Pole Foundation Detail

IDAHO TRANSPORTATION DEPARTMENT RWIS BUILDOUT Federal Aid Project No. ITS-2006(023)

RWIS Site Typical

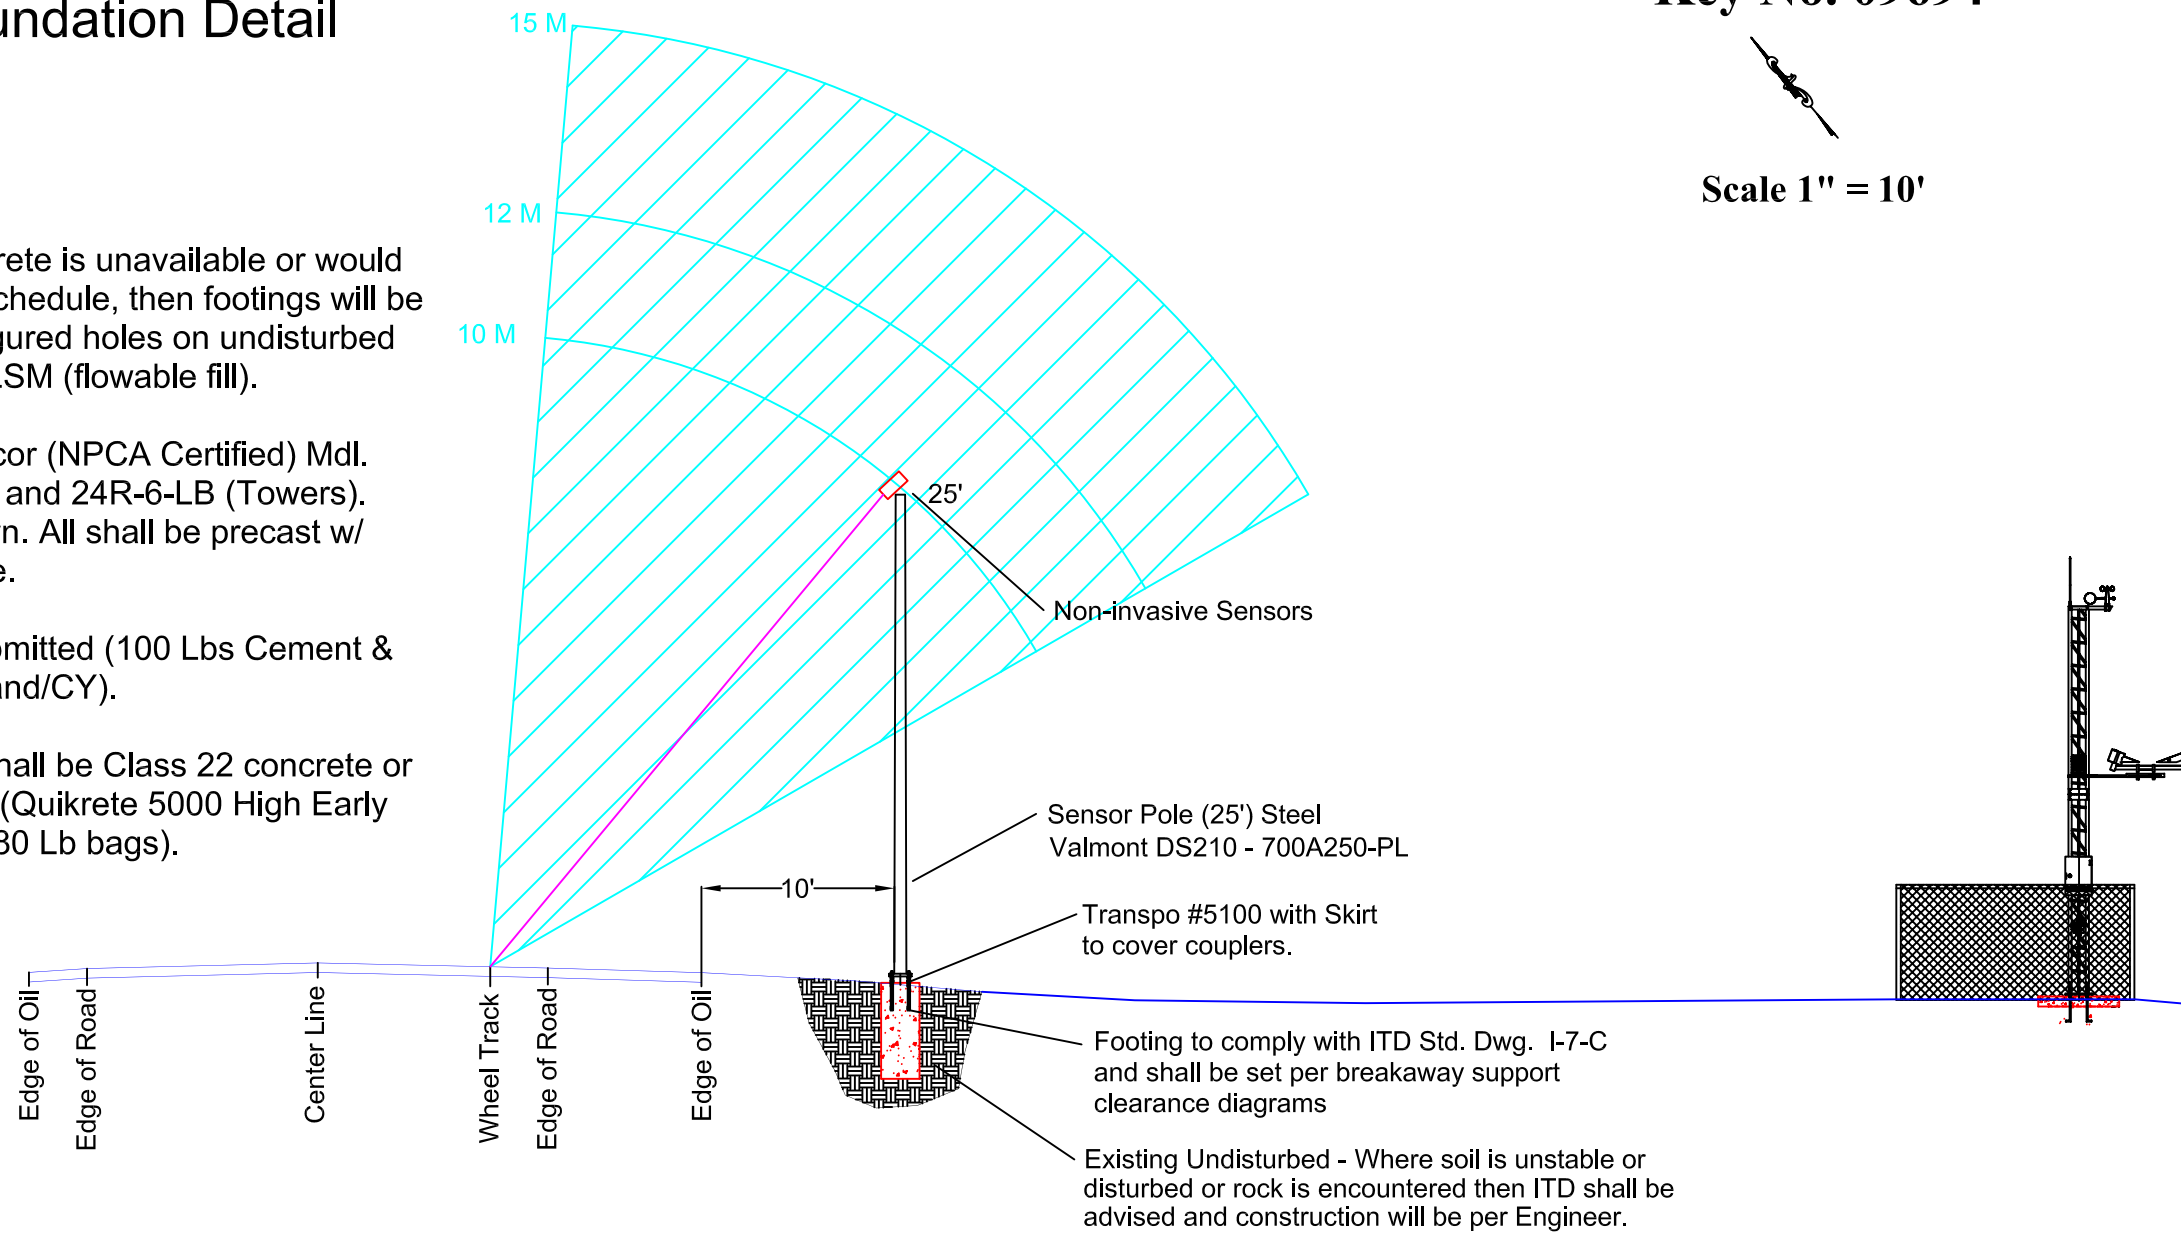
Where Class 30 concrete is unavailable or would severely impact the schedule, then footings will be precast and set in augured holes on undisturbed and backfilled with CLSM (flowable fill).

Footings shall be Amcor (NPCA Certified) Mdl. No. 24R-5-LB (Poles) and 24R-6-LB (Towers). Slab shall be as shown. All shall be precast w/ ITD Class 30 concrete.

CLSM shall be as submitted (100 Lbs Cement & 2550 Lbs Concrete sand/CY).

Fence post footings shall be Class 22 concrete or shall be as submitted (Quikrete 5000 High Early Strength Concrete in 80 Lb bags).
